**ADDENDUM NO. 03
September 26, 2022**

**WINDSONG ELEMENTARY SCHOOL ADDITION & RENOVATION ISSUE FOUR PROPOSAL
FOR FRIENDSWOOD I.S.D.**

Prepared by: PBK
11 Greenway Plaza, 22nd Floor
Houston, TX 77046-1104
PBK Project No: 20380

A-201D.1

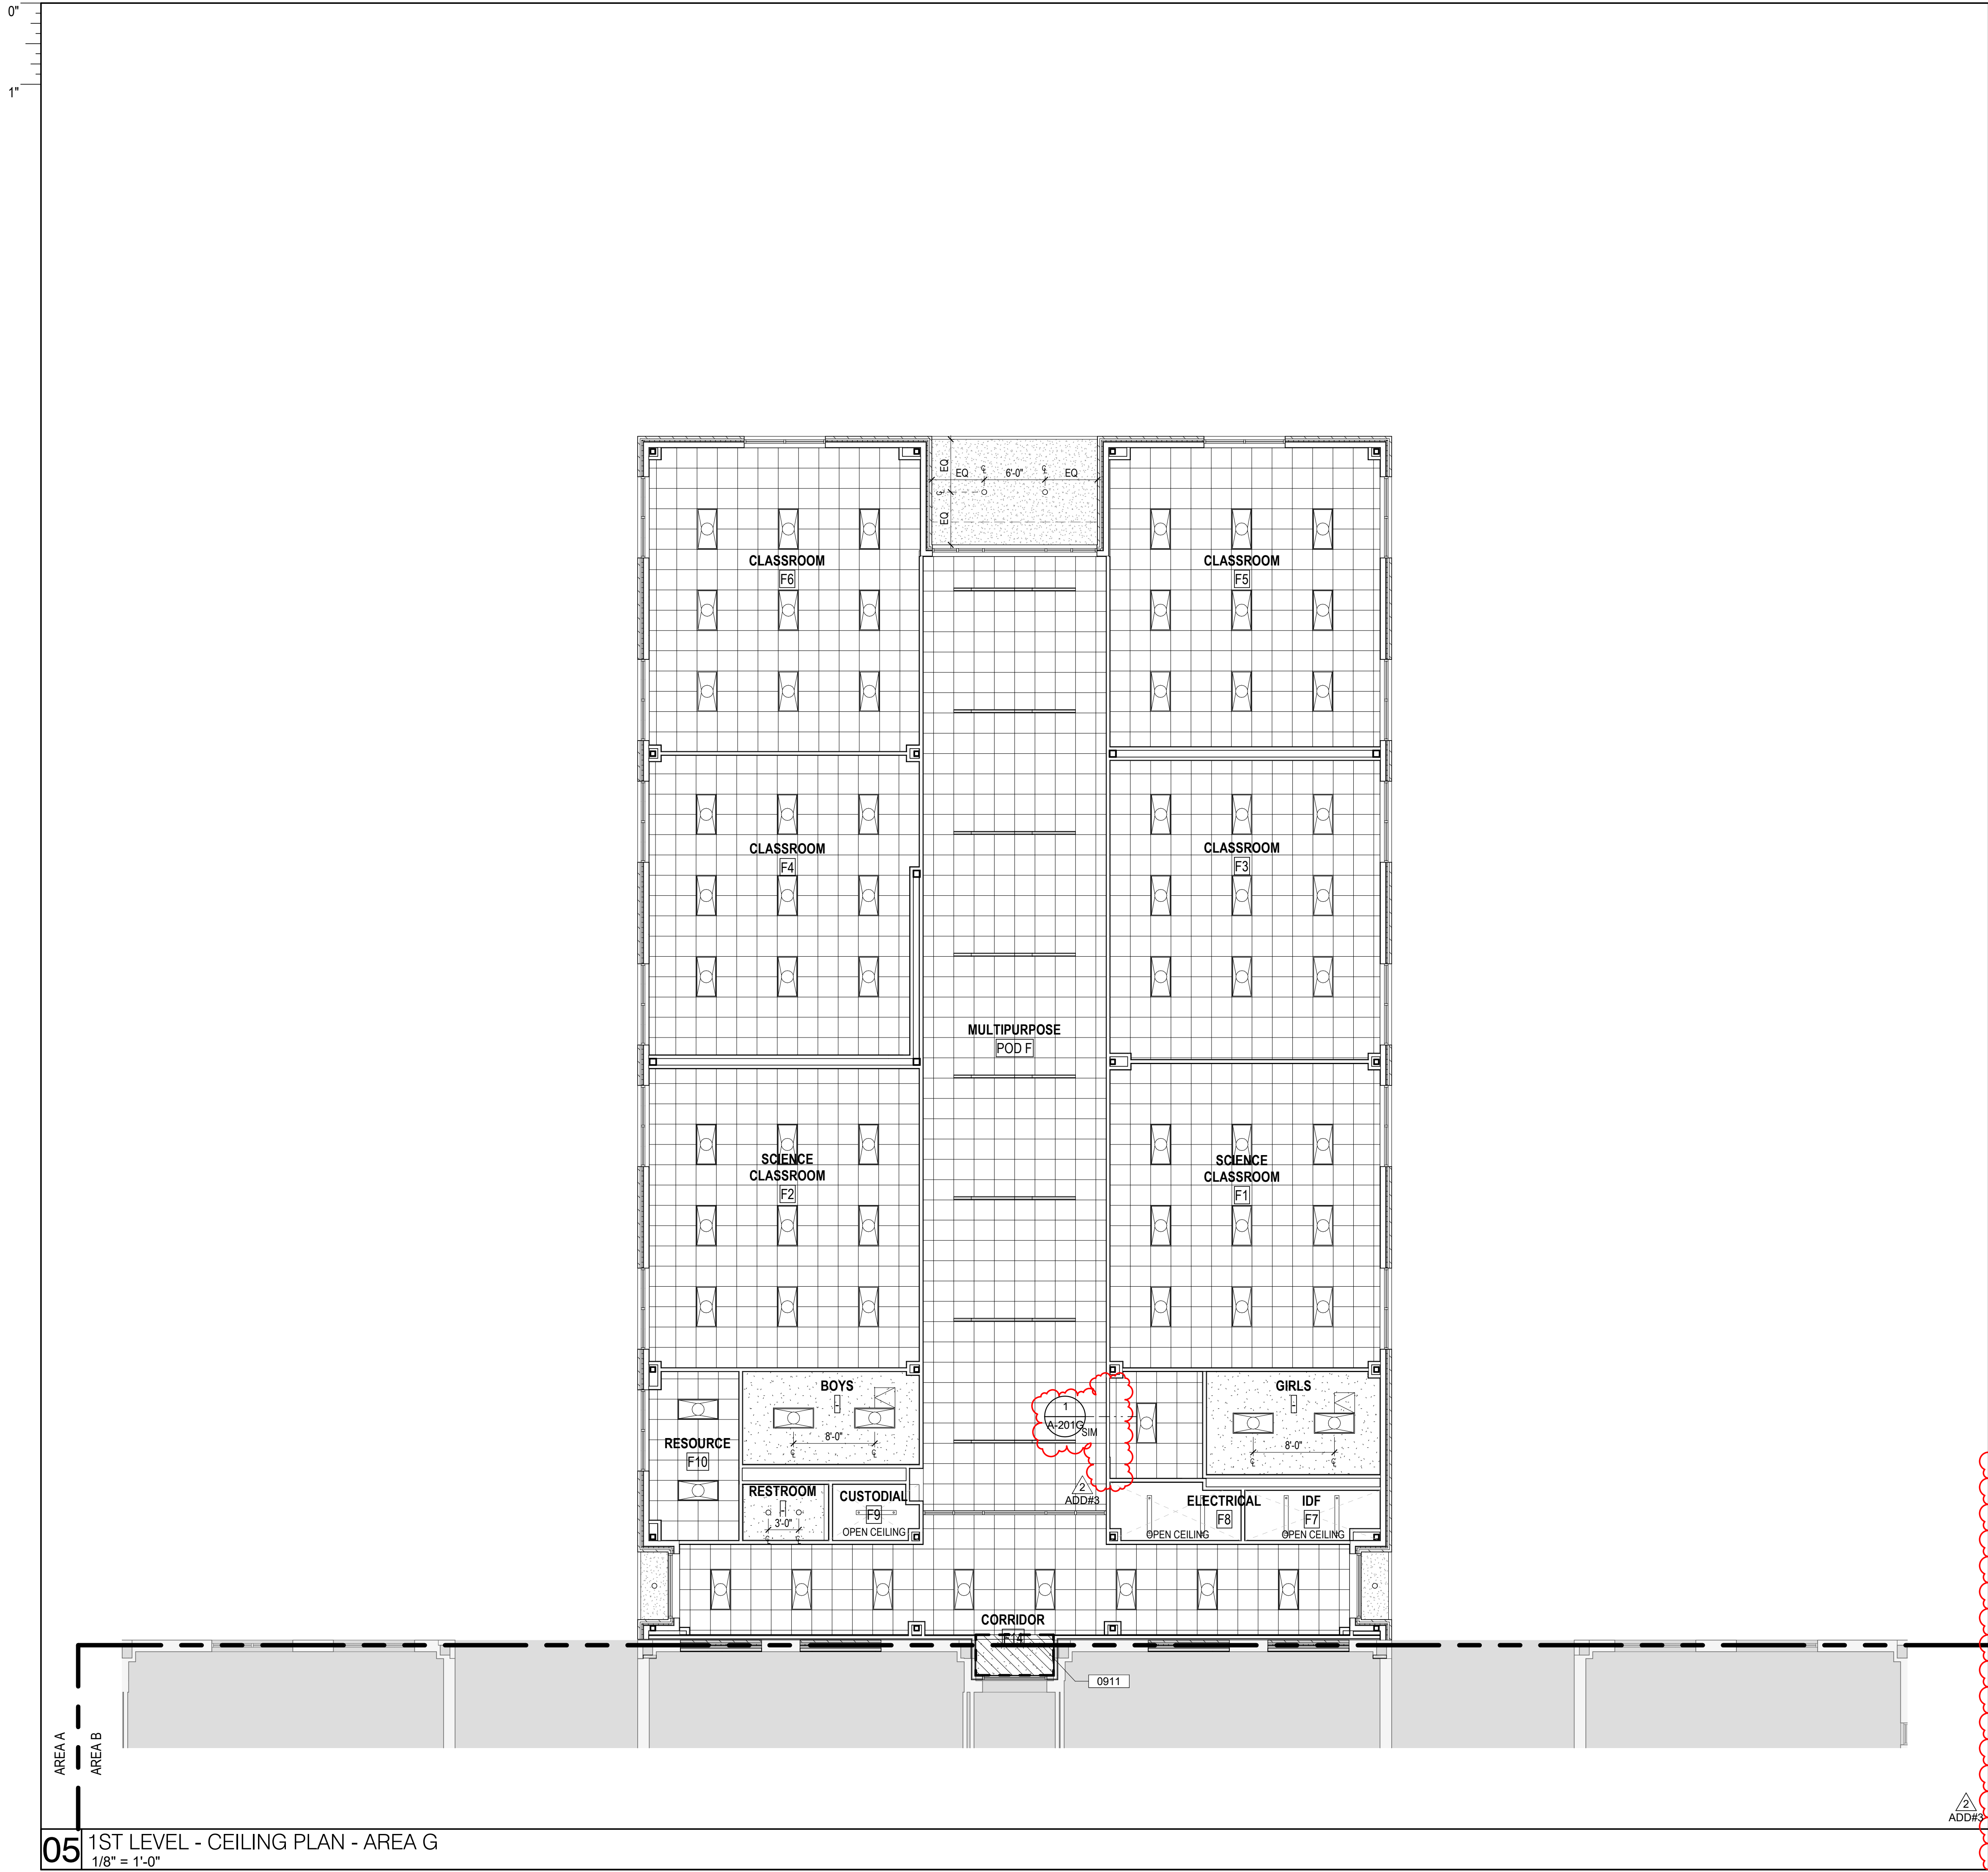
D. Fire extinguisher to be semi-recessed.
- Item No. 62 **A-101G.1 Alternate NO.01:** Door panels and storefront finish to be Clear Anodized
- Item No. 63 **A-201D.1 Alternate No. 08 :** Sheet added in it's entirety, refer to attachment.

A-201G

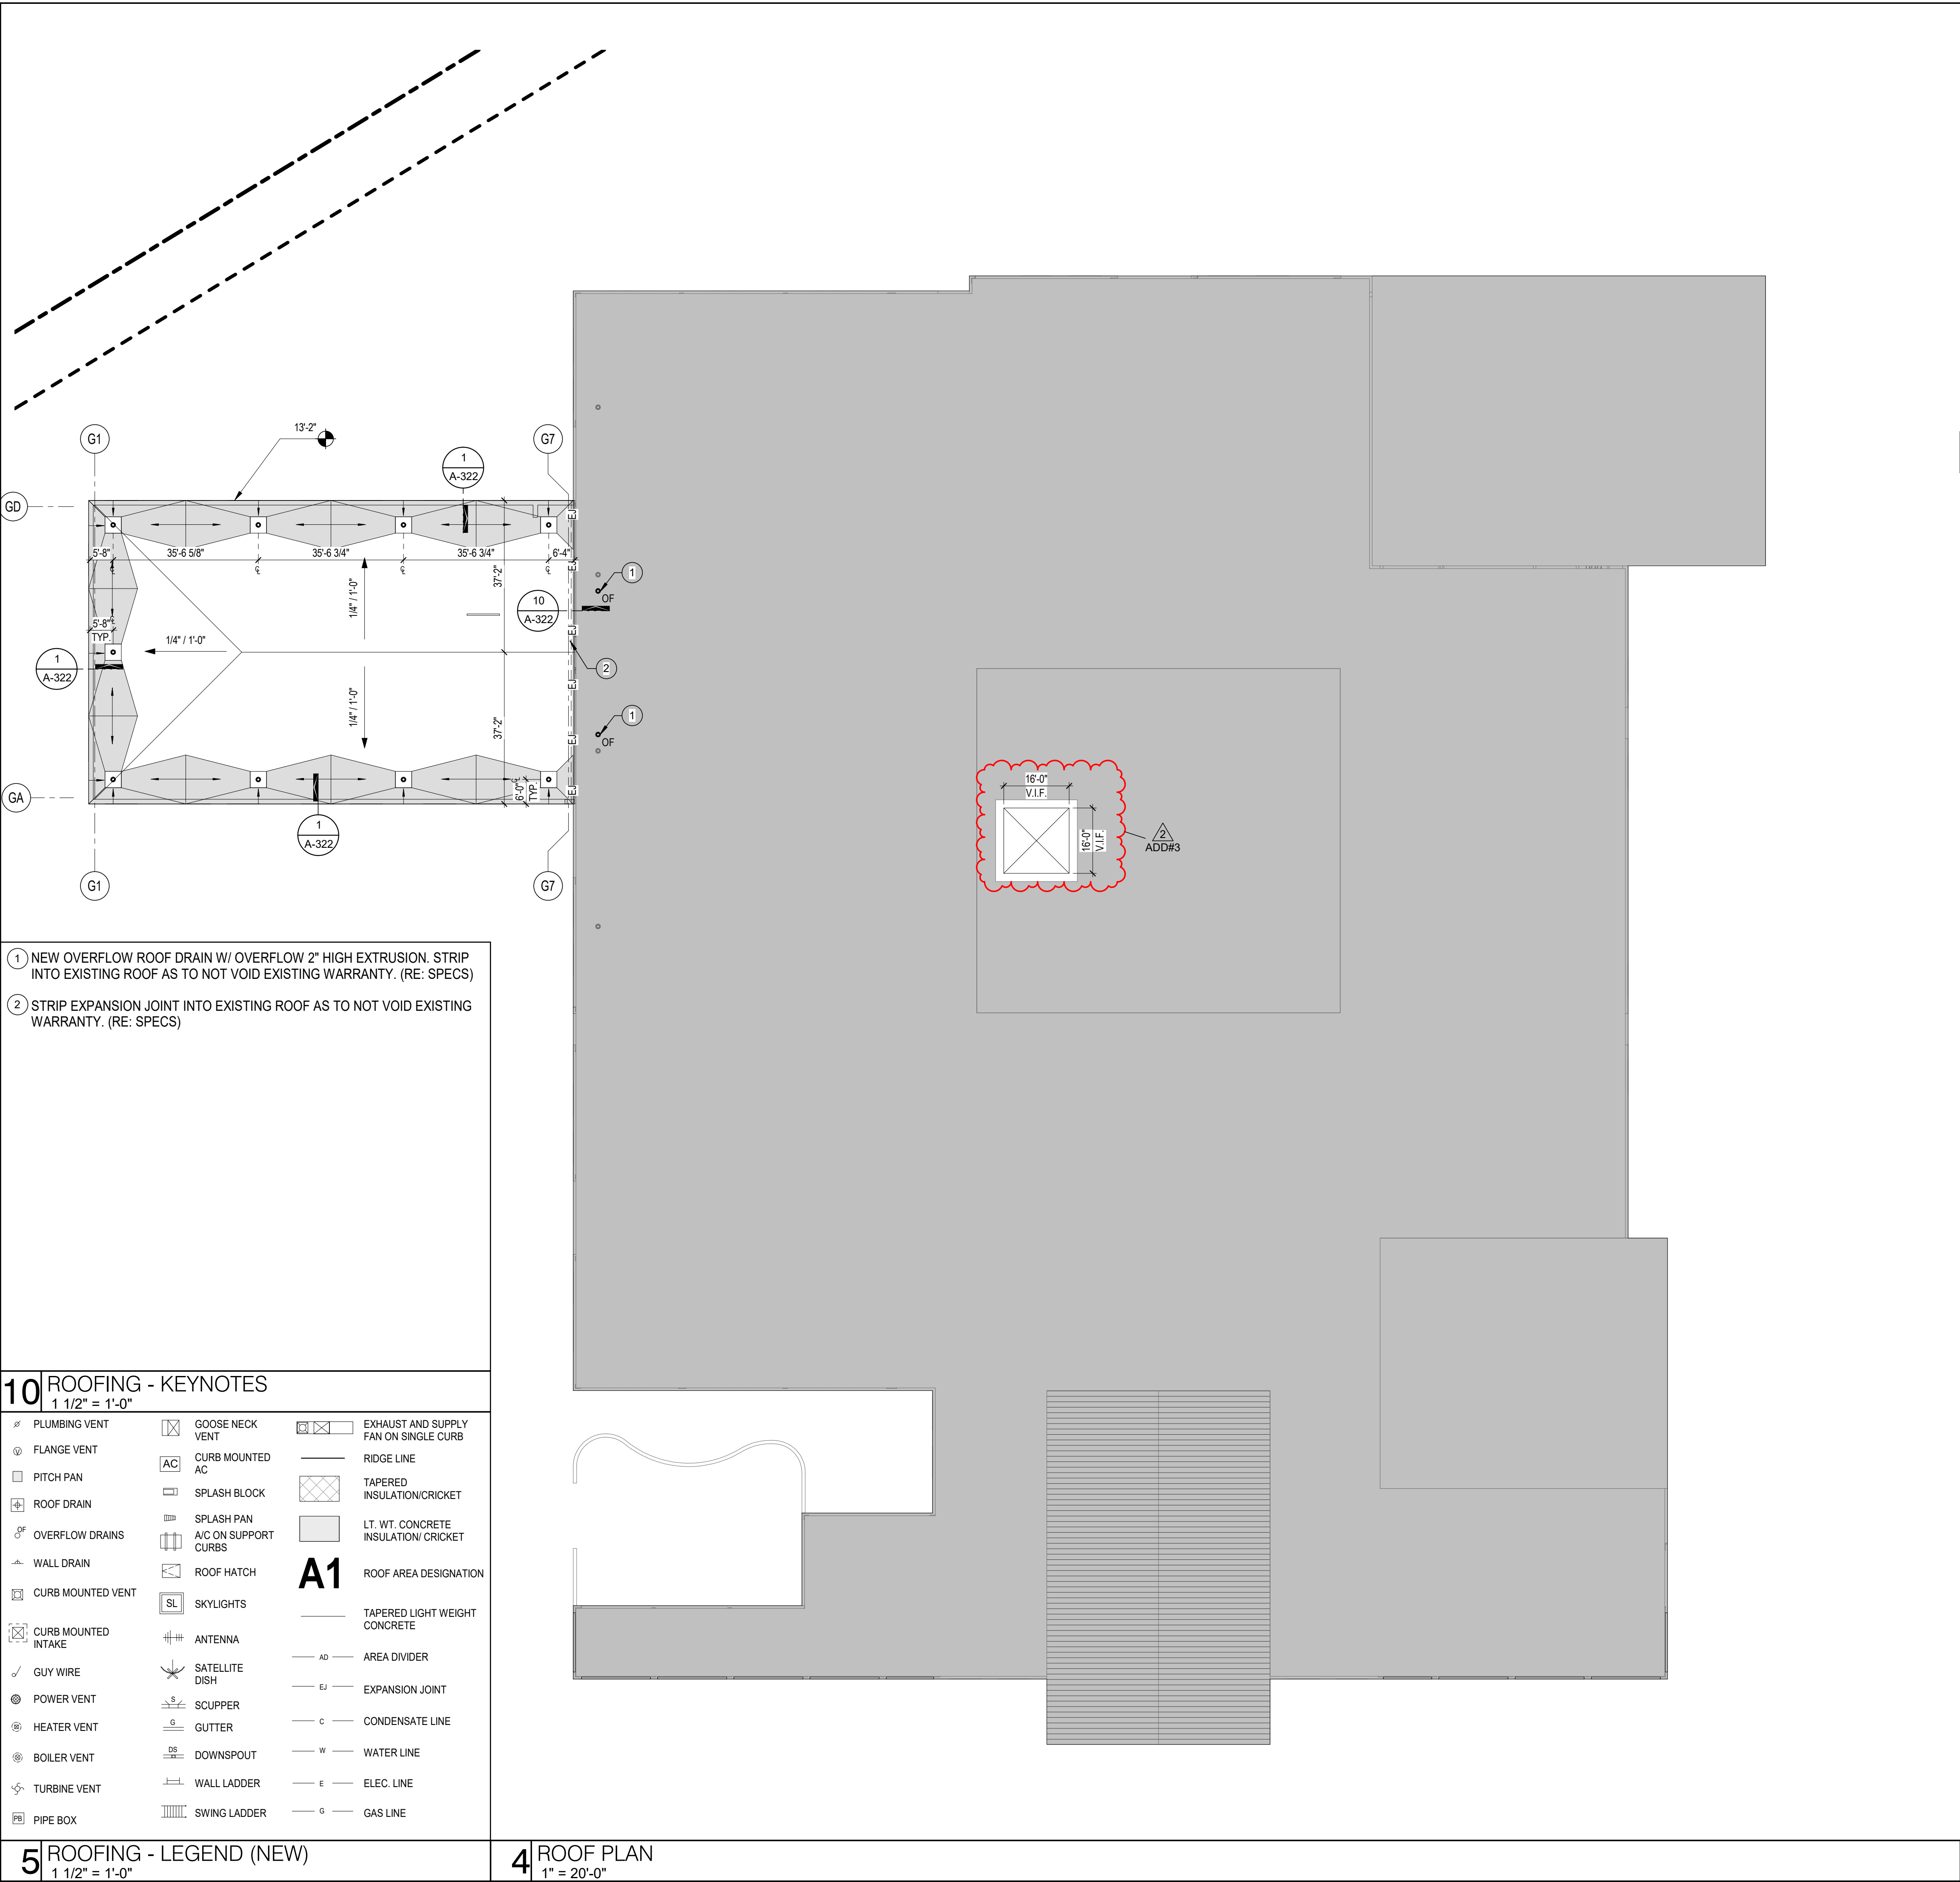
- Item No. 64 **A-201G 1ST Floor Ceiling Plan – Area G:** Add ceiling furdown and detail, refer to attachment.
- Item No. 65 **A-301 Roof Plan - Composite**

A-301

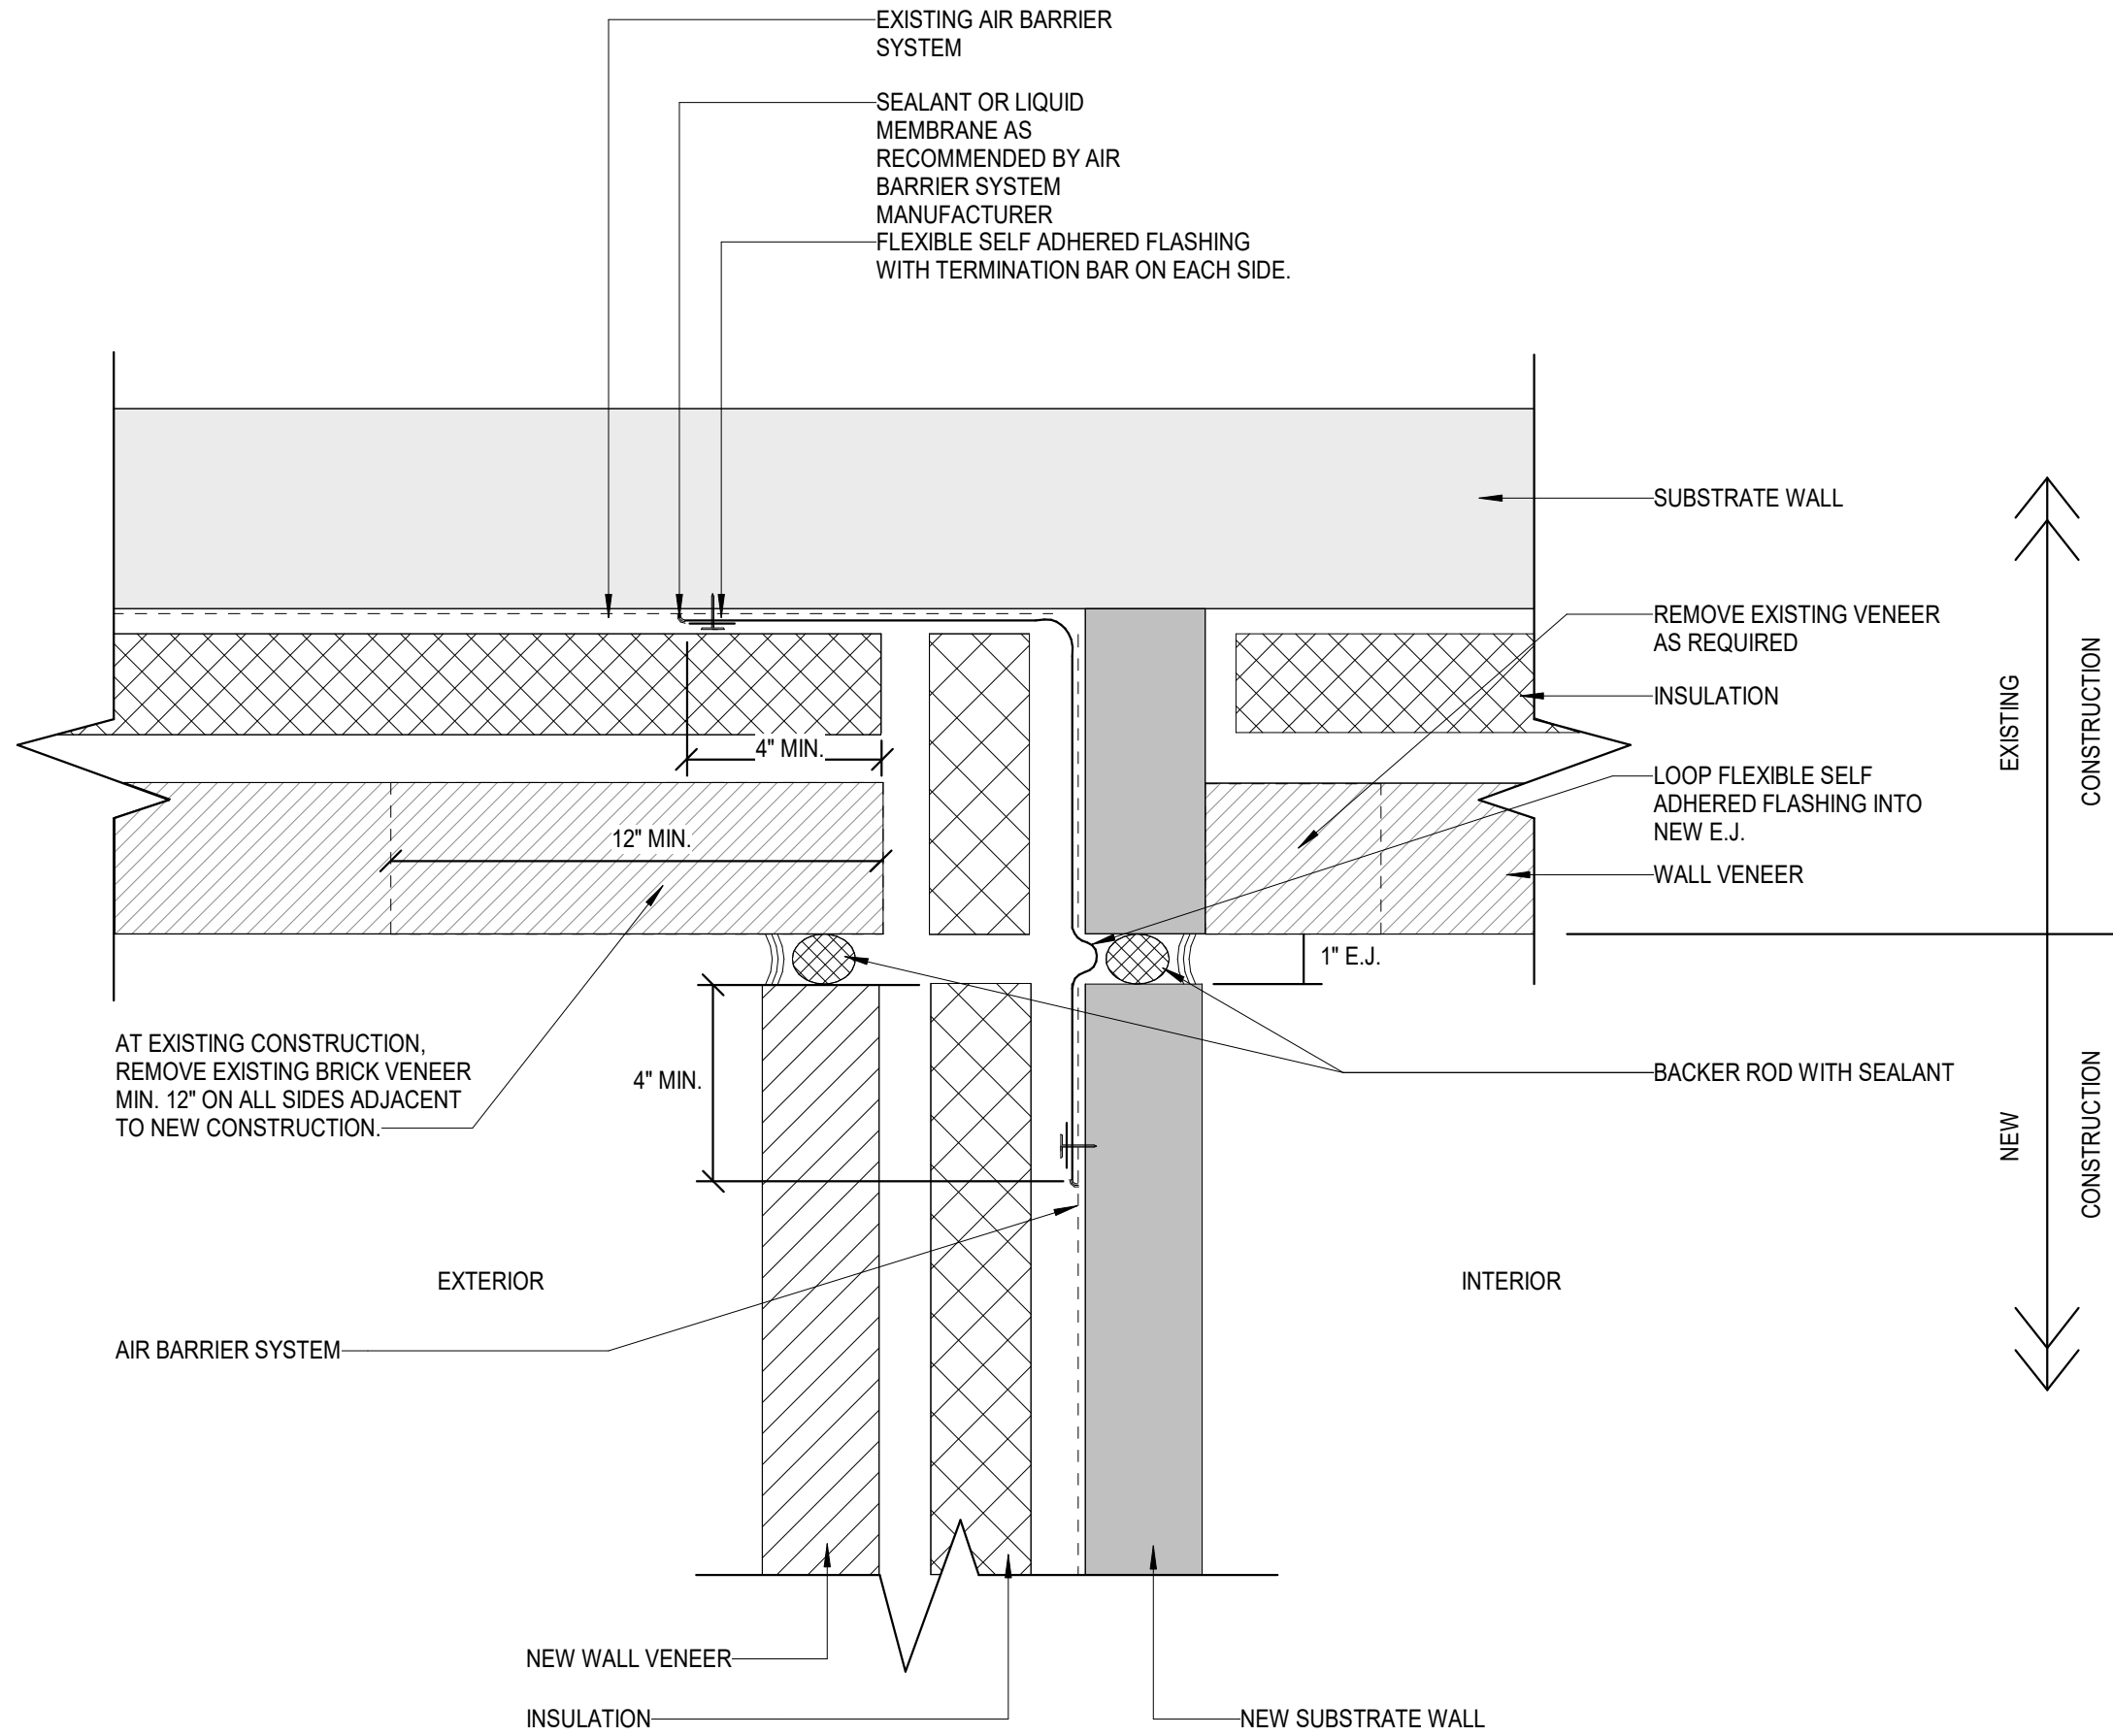
- Item No. 3 Are there curb dimensions available they can provide?
 - A. **See revised A-301.**

A. Added skylight dimension, refer to attachment.
- Item No. 66 **A-325 Building Envelope Details (New to Exist)**
 A. Remove detail 11 in its entirety.
